**MANDATORY SERVICE BULLETIN NO. MSB 40NG-080 REV. 2**  
**SUPERSEDES MSB 40NG-080 REV. 1**

Model: DA 40 NG

Inspection of starter wiring connection.

**WORK INSTRUCTION WI-MSB 40NG-080 REV. 2**  
**SUPERSEDES WI-MSB 40NG-080 REV. 1**

Figure 1 - Correct starter wiring connection.

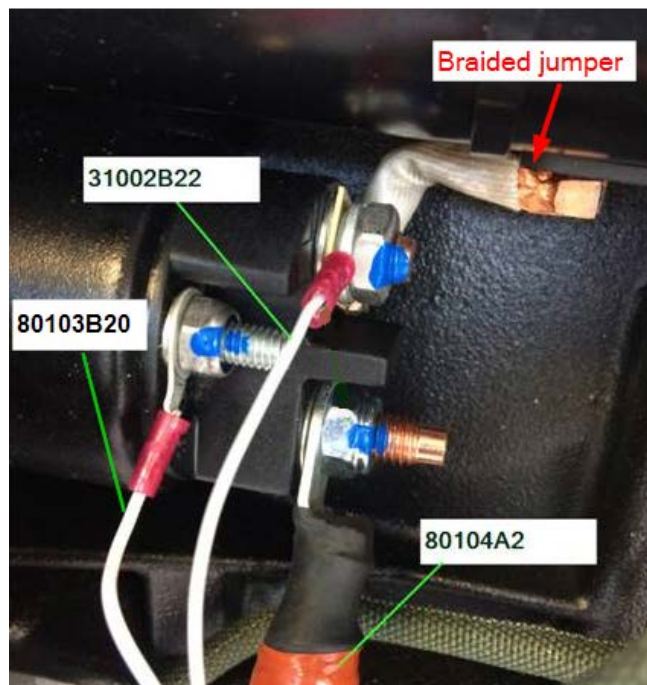
1. Disconnect the main battery for maintenance. Refer to AMM Section 24-31.
2. Remove the top cowling. Refer to AMM Section 71-10.
3. Inspect the starter wiring for correct connection. Refer to Figure 1.
  - The terminal 31002B2 must be connected along with the braided jumper.

4. If the wire 31002B22 is connected to the same attachment as the braided jumper as shown in Figure 1, that means that the connection is correct and you can proceed to step 8.
5. If the wire 31002B22 is not connected to the same attachment as the braided jumper, the connection is incorrect and you must proceed to the next step.

6. Remove wire 31002B22 from the incorrect location, and reinstall it in the correct location. Refer to Figure 1.
7. Clean the working areas and check for foreign objects.
8. Connect the main battery after maintenance. Refer to AMM Section 24-31.
9. Check all altered, replaced, repaired parts for proper function.
10. Install the top cowling. Refer to AMM Section 71-10.
11. Do an engine ground run-up. Refer to AMM Section 71-00.
12. Make all necessary entries into the logbooks.
13. Submit the execution report to [Techpubs@diamondaircraft.com](mailto:Techpubs@diamondaircraft.com).
